TRUCK, HEAVY, MC3 (MACK) - ALL TYPES  
FITTING OF WARNING PLATE SPARE WHEEL JACK AND MODIFICATION RECORD PLATE  
MODIFICATION INSTRUCTION

Issue of this instruction is authorized by Army Office (TVA B VEH TH-21)

Reference: A. VEH G 799-1.

FIG 1 - LOCATION OF WARNING PLATE AND MODIFICATION RECORD PLATE

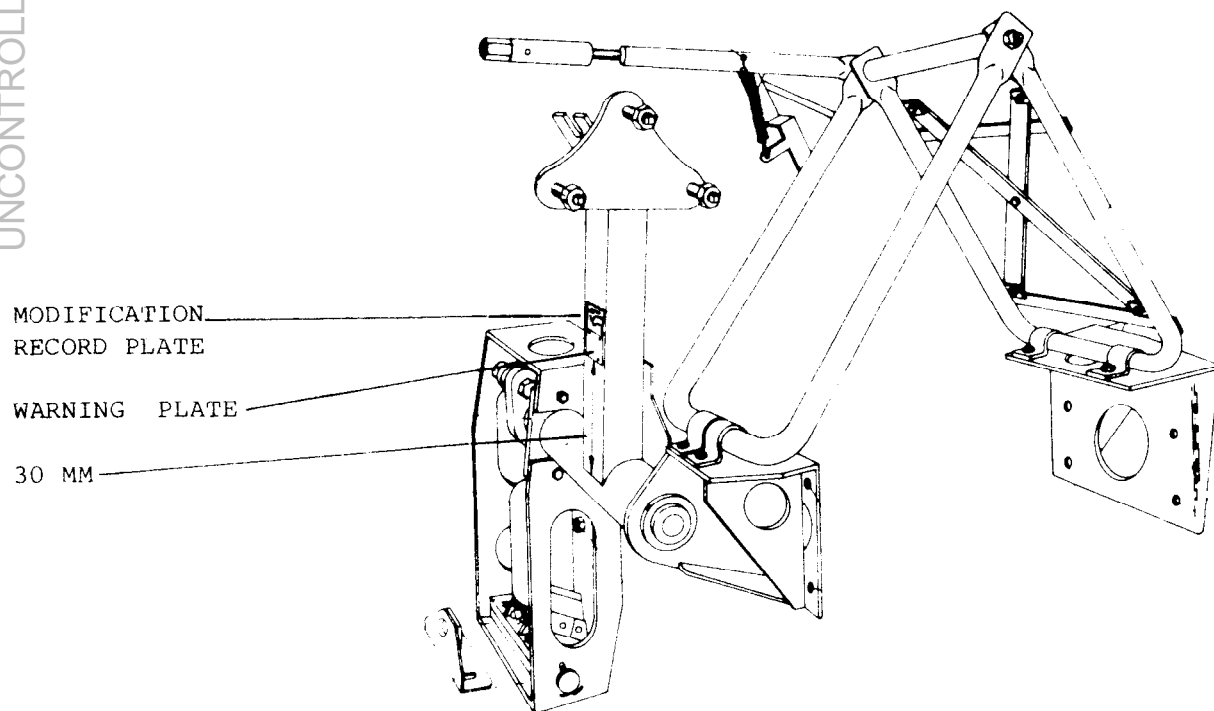
1. This EMEI replaces VEH G 707-1, 717-1, 727-1, 737-1, 747-1, 757-1, 767-1 and 777-1.
2. This instruction details the fitting of the plate that warns operators to keep clear of the spare wheel while it is being raised or lowered. Only those trucks that were delivered prior to the warning plate being fitted during production are effected. Also included, is the fitting of a modification record plate to all subject vehicles with the exception of the TRUCK, WRECKER HEAVY MC3 MACK.

8. To carry out the modification, refer to Fig 1 and proceed as follows:
  - a. Position the warning plate, item 1 from Table 1, as shown in Fig 1.
  - b. Using the warning plate as a template, mark out the holes.
  - c. Drill four 1/8 inch diameter holes through the spare wheel carrier support arm.
  - d. Using suitable 1/8 in diameter pop rivets, secure the warning plate in position.
  - e. Position the modification record plate, item 1 from Table 2, as shown in Fig 1.
  - f. Drill four 1/8 inch diameter holes through the modification record plate and the spare wheel carrier support arm.

1. Drill the holes adjacent to the existing holes in the modification record plate.
  - g. Using suitable 1/8 inch diameter pop rivets, secure the record plate in position.
9. Modification Record Plate. Deface the numeral 1 on the modification record plate.
